VERMONT YANKEE NUCLEAR POWER CORPORATION

DOCKET NO. 50-271

AMENDMENT TO FACILITY OPERATING LICENSE

Amendment No. 62  
License No. DPR-28

Figure 3.6.1  
 Reactor Vessel Pressure  
 Temperature Limitations  
 for Operation Through 1.15E8MWH (t)  
 RTNDT @ 1/4T = +90°F @ 3/4T = 750F

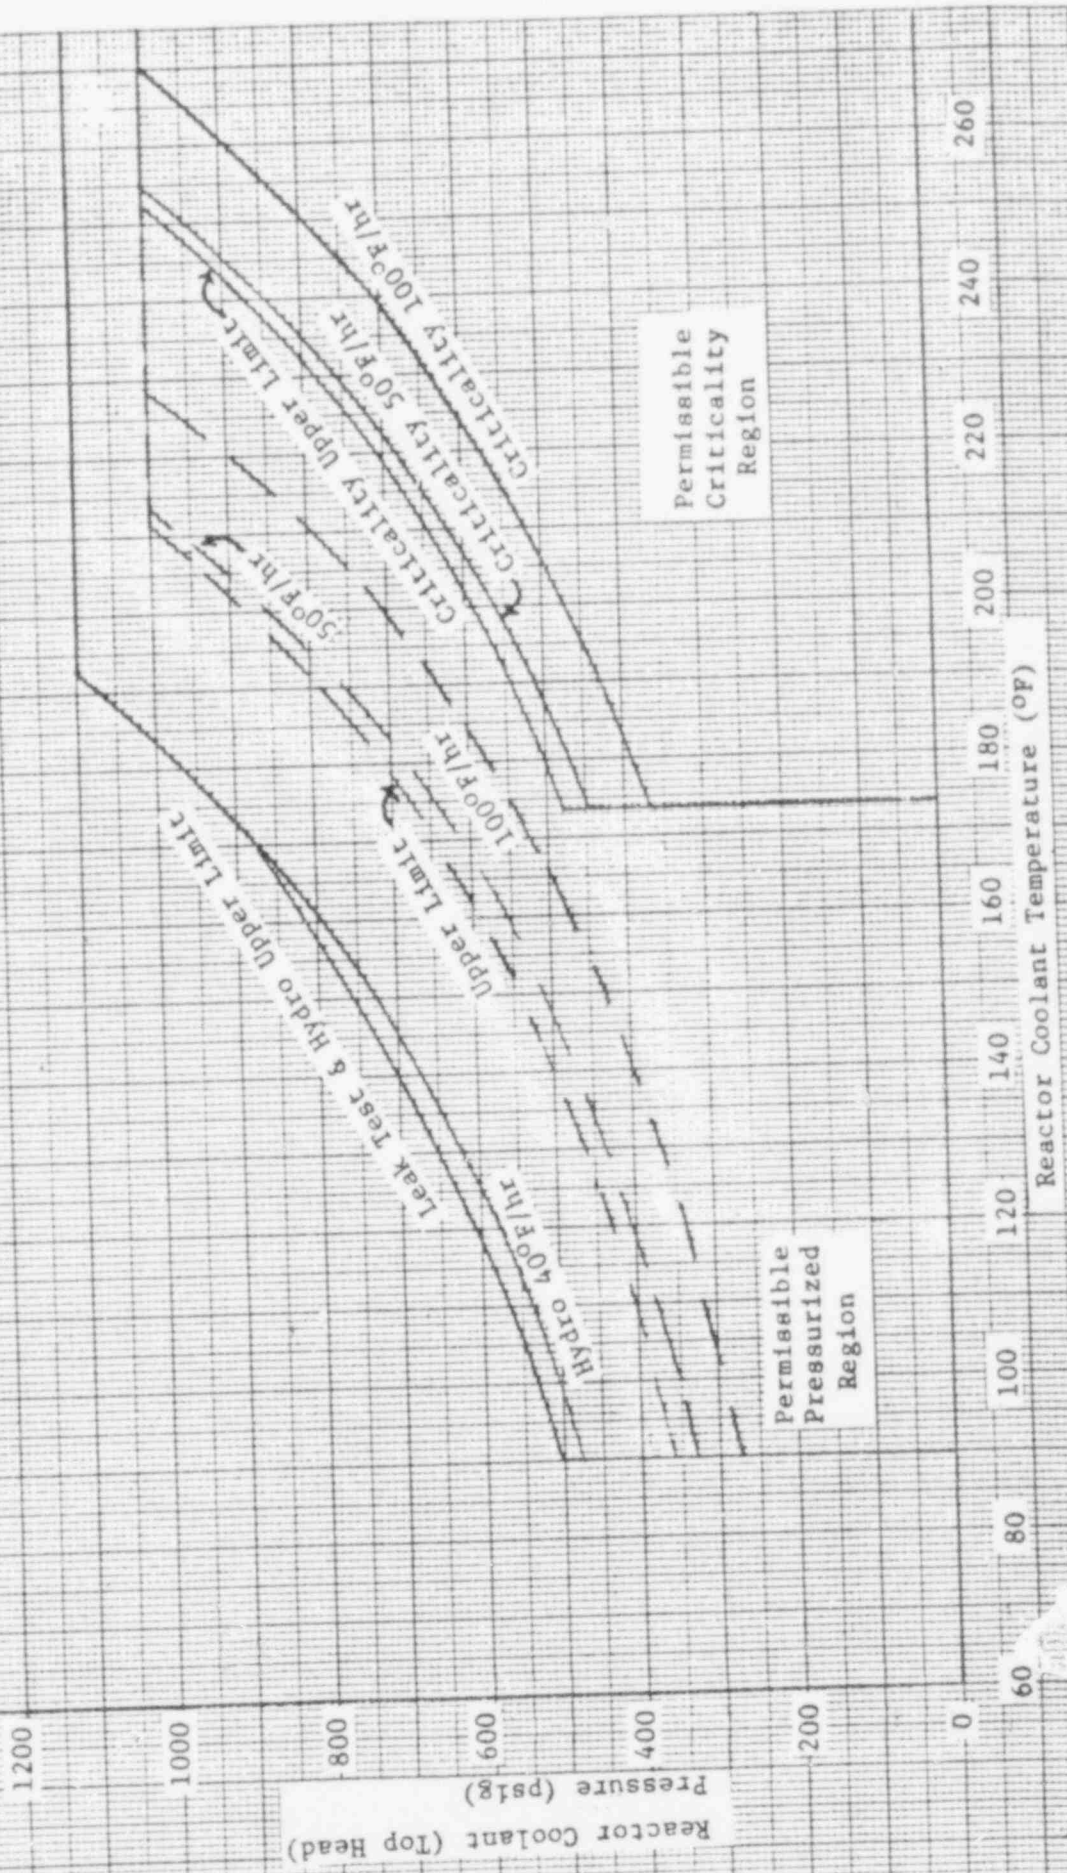
1. Replace the following pages of the Appendix "A" Technical Specifications with the enclosed pages. The revised pages are identified by Amendment number and contain vertical lines indicating the area of change.

The pressure-temperature limit lines shown on Figure 3.6.1 for reactor criticality and for inservice leak and hydrostatic testing have been provided to assure compliance with the minimum temperature requirements of Appendix G to 10 CFR 50 for reactor criticality and for inservice leak and hydrostatic testing.
